URBAN DESIGN CONSULTATION RESPONSE

Design Officer	Azhar Kapadi
Date	Set 2 Comments 11.08.26 Original Comments 20.05.26
Application Reference	PL/2026/0196
Address	Land at Egerton Street (Former New Jerusalem Church), Middleton, M24 4QD
Proposal	Erection of seven residential dwellings (Use Class C3) with associated access works including formation of a new dropped kerb, parking, bin storage, landscaping and private amenity space.

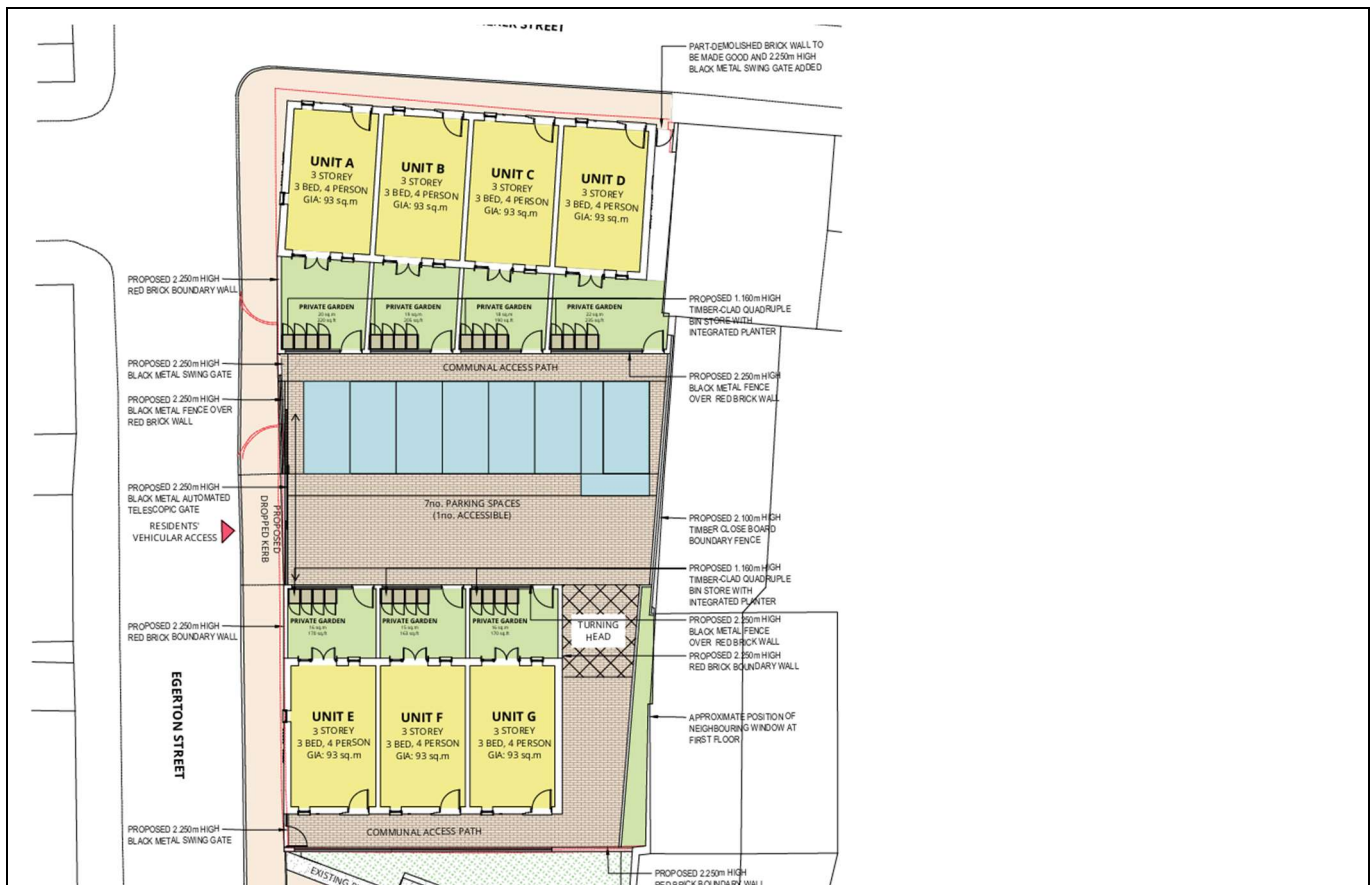
Unpleasant and visually uninteresting side elevations - quite prominent. Simplify as shown with stepped brickwork- Unlikely to have cost impact. Further interest to gables on the street side.

??
If in the background it
needs to be shown as the
background

Boundary treatments make this look like rear gardens. Better detailing and materiality needs to be ensured. Lower wall height. Why the sudden change from open to solid wall?
